FUEL STATION #4335
11550 MERIDIAN MARKET VIEW
FALCON, CO

PROFESSIONAL OF RECORD	TB
PROJECT MANAGER	JPD
DESIGNER	JSC
CEI PROJECT NUMBER	32639
DATE	2/21/2023
REVISION	REV-1

LANDSCAPE PLAN
SHEET TITLE
SHEET NUMBER

50A	TREE PLANTING
50B	SHRUB PLANTING

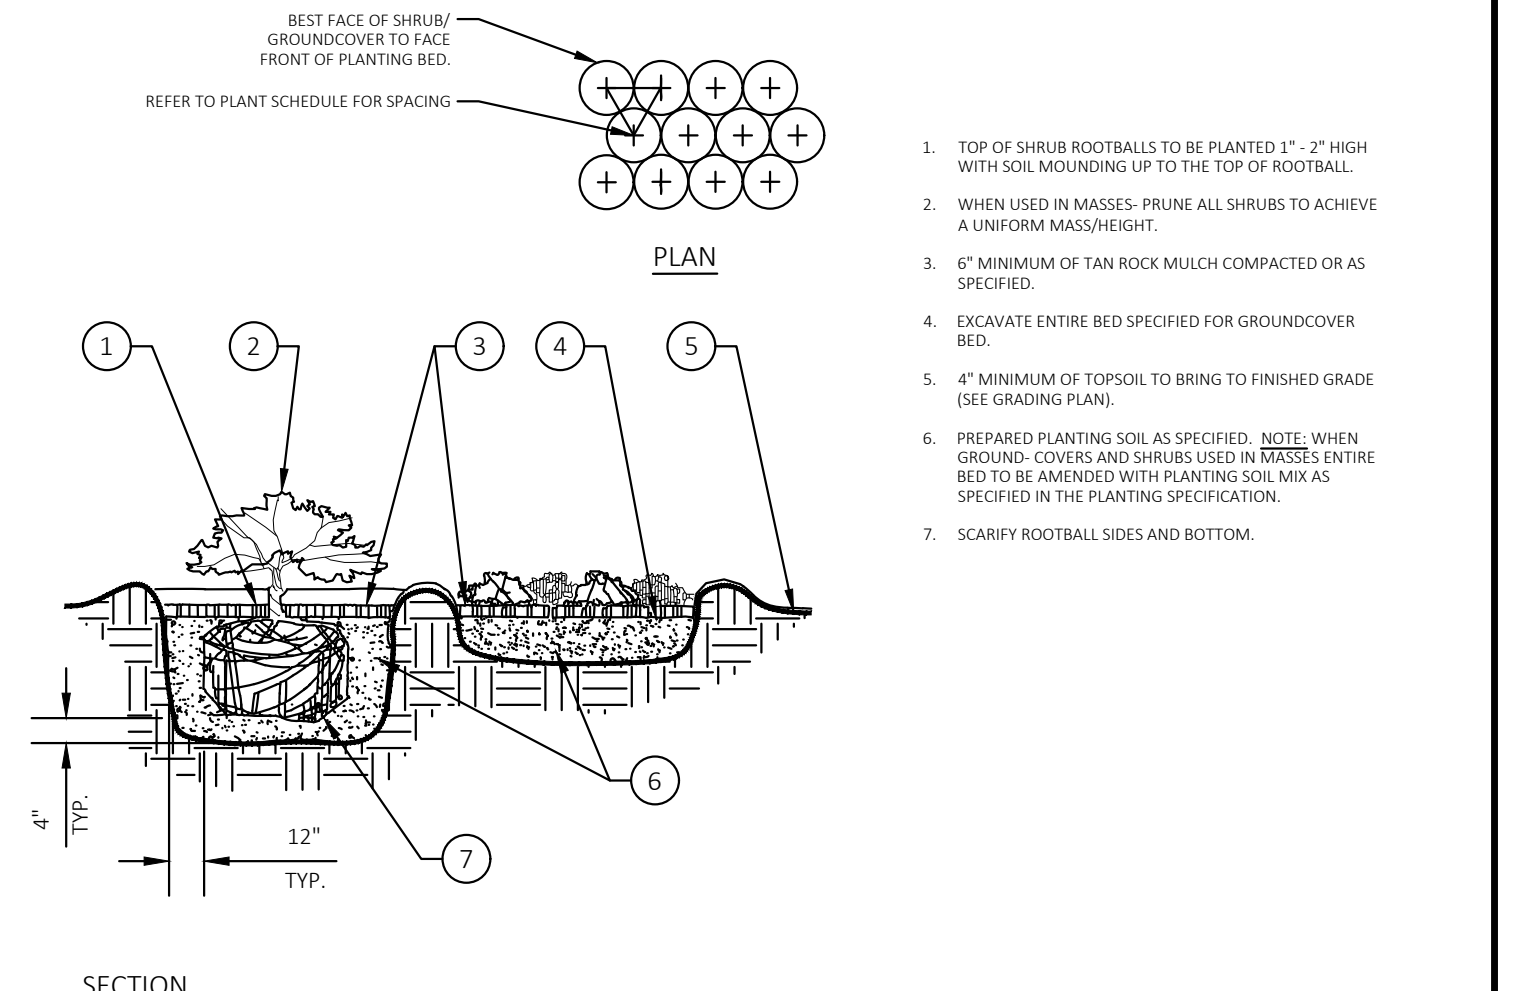
please change to the proper numerical value

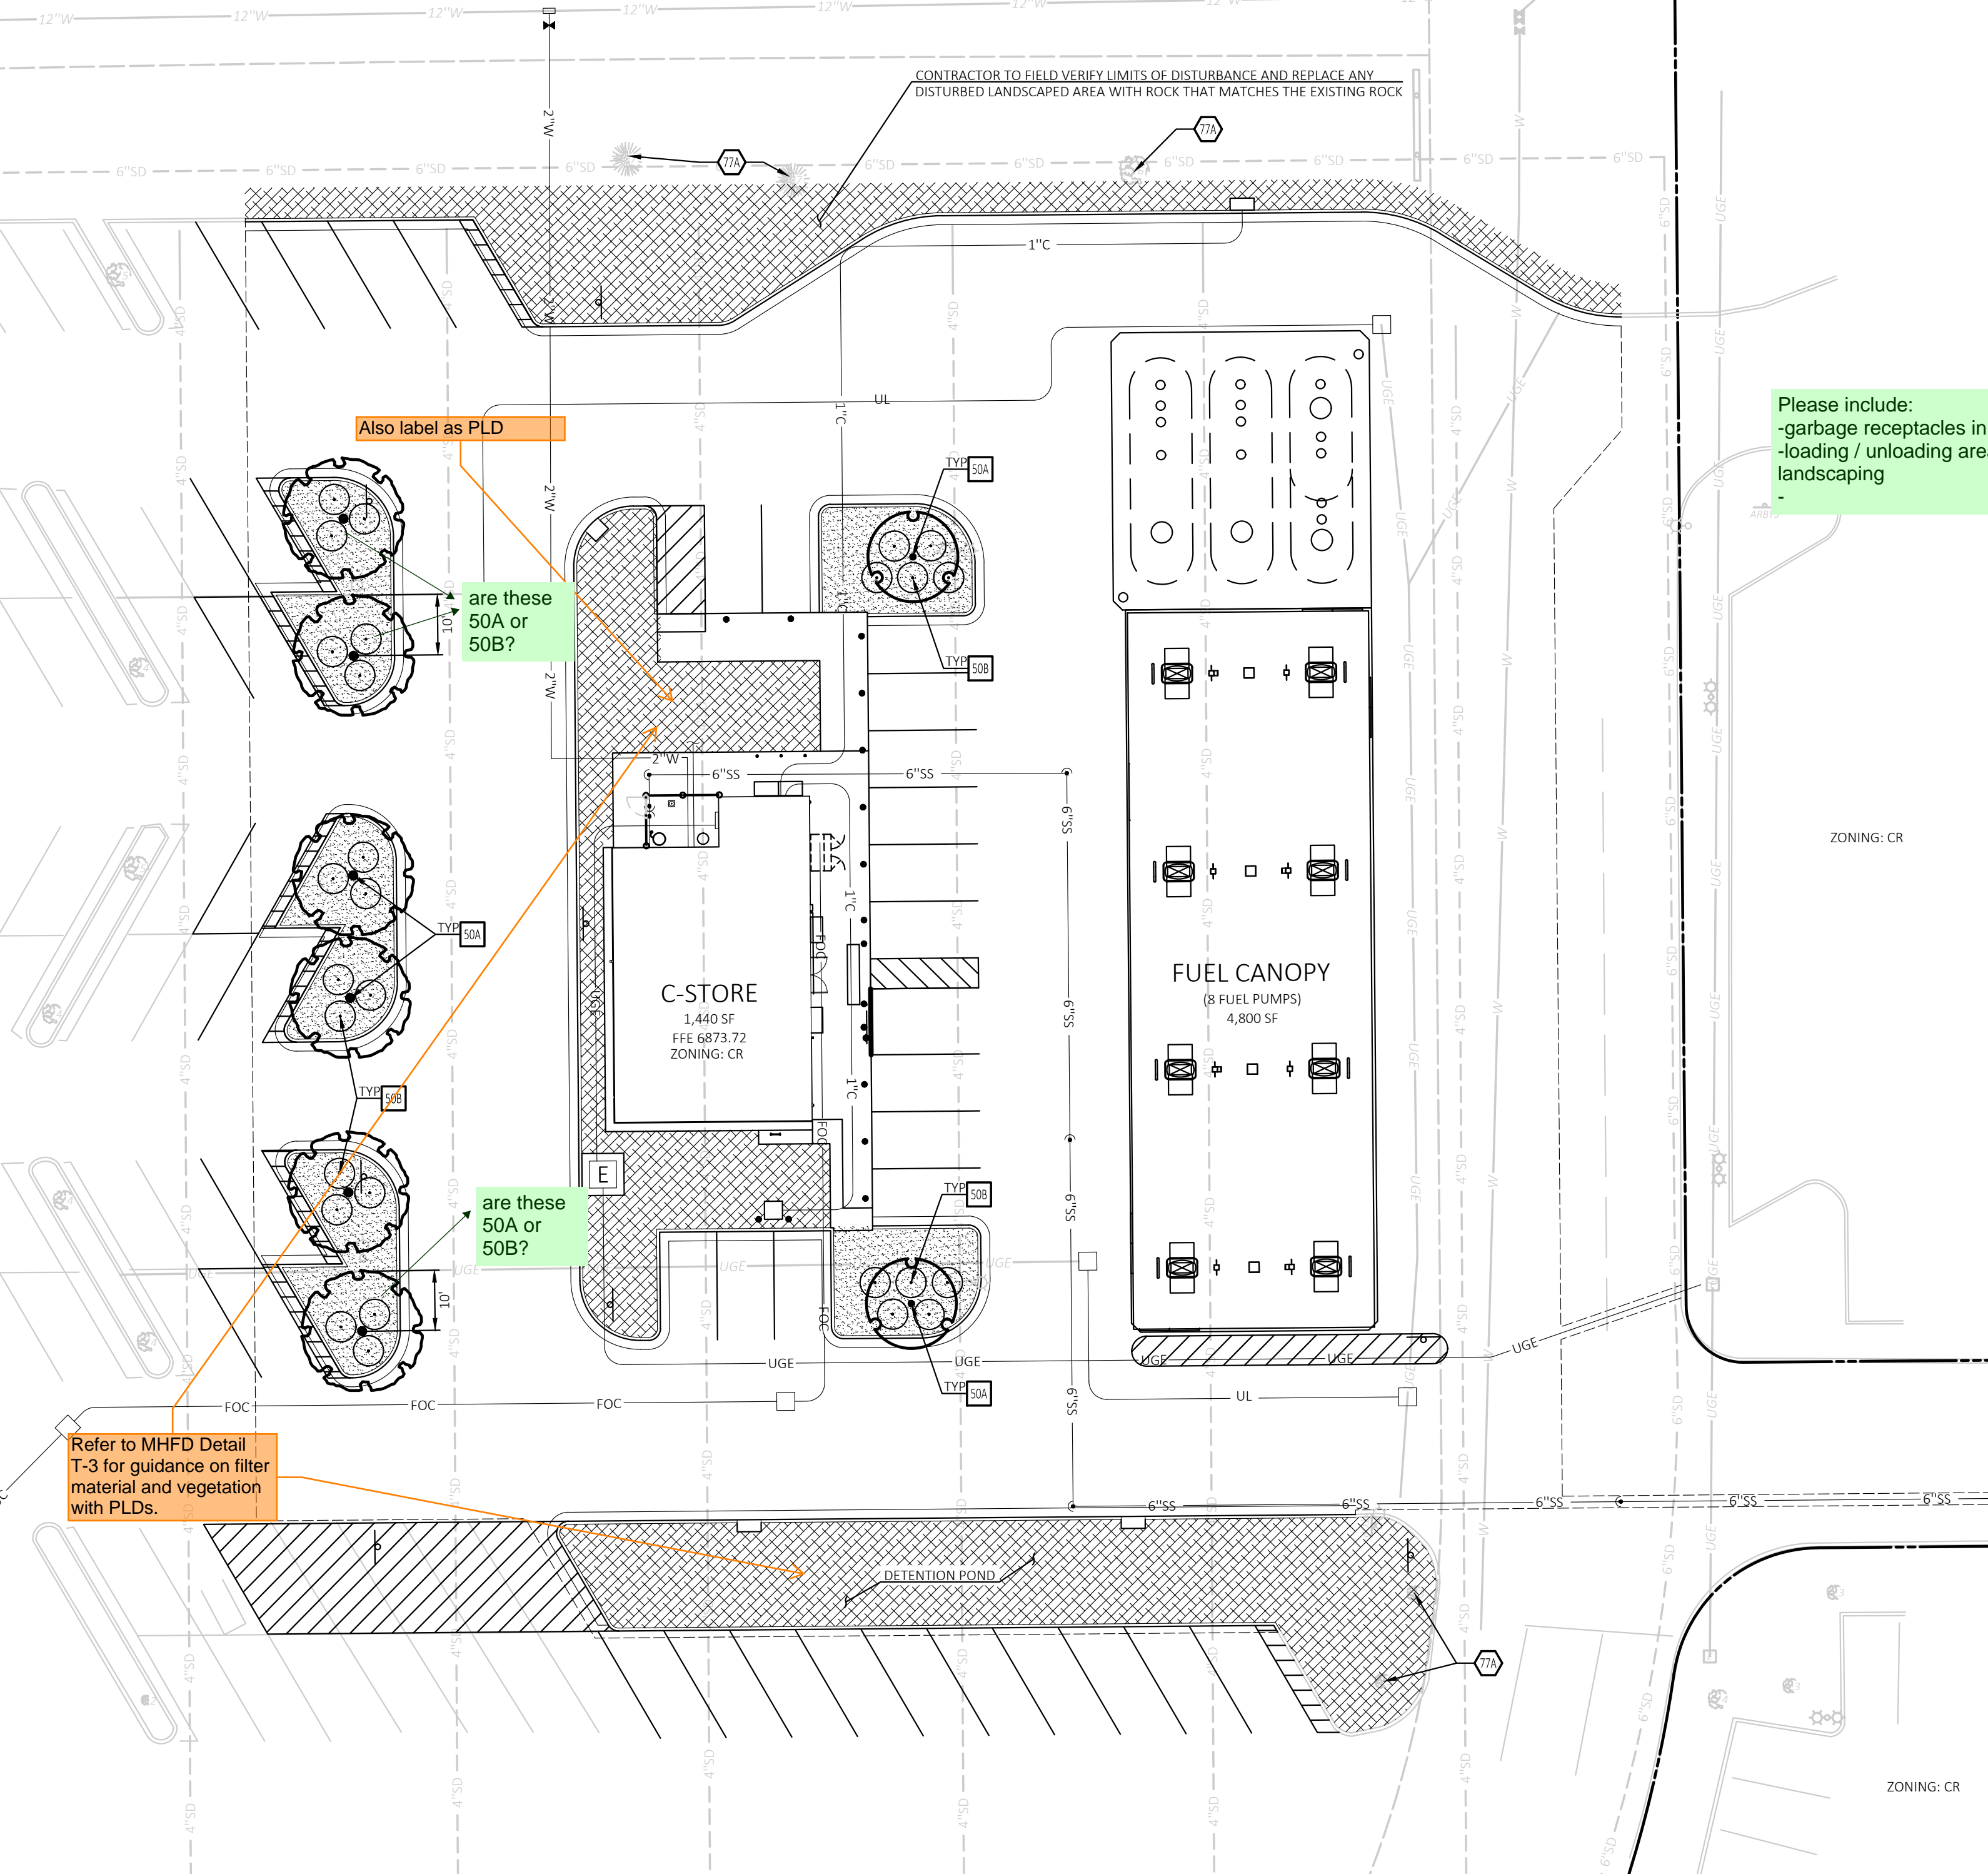
Please include the existing tree on this table, with type, symbol, and size included too

77A EXISTING TREE TO REMAIN → 5 existing trees are depicted on this plan. 7 trees are claimed to be on this site, please update

Also label as PLD

are these 50A or 50B?

are these 50A or 50B?

Refer to MHFD Detail T-3 for guidance on filter material and vegetation with PLDs.

Please include: -garbage receptacles in relation to landscaping -loading / unloading areas in relation to landscaping
